BCA ASSESSMENT REPORT

60 Wallgrove Road, Eastern Creek

Client: Mirvac

Revision 2

Figure 1 – Areas of Non-Compliant Perimeter Vehicular Access per BCA C2.4.

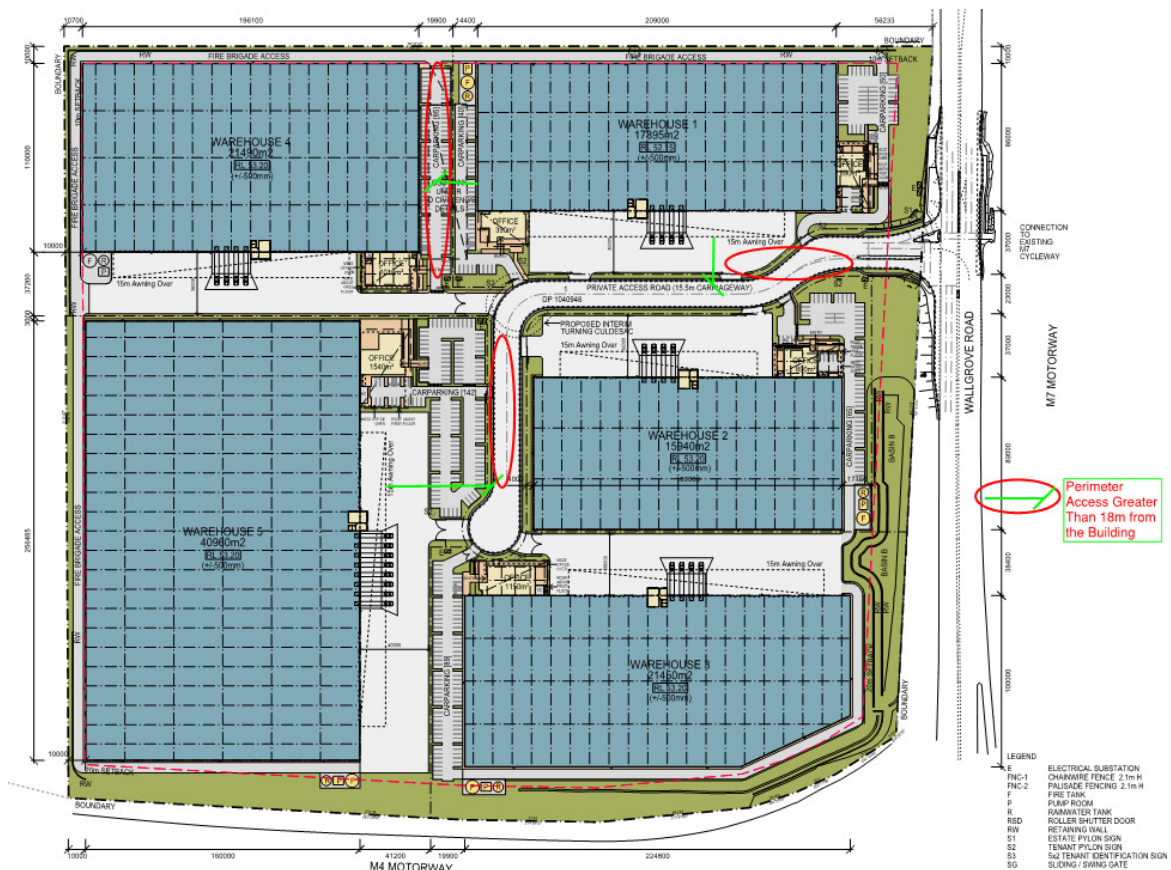
Comments: The proposed warehouse buildings do not comply with the provisions of C2.4 and thus the following non-compliance issues are required to be addressed as an alternative solution by the Fire Safety Engineer to demonstrate compliance with Performance Requirement CP9 - refer to the dot points and the diagram below for details of the proposed non-compliance issues:

- Vehicular Access is greater than 18m from the external wall of Warehouse 1, & 5 – refer to diagram below.
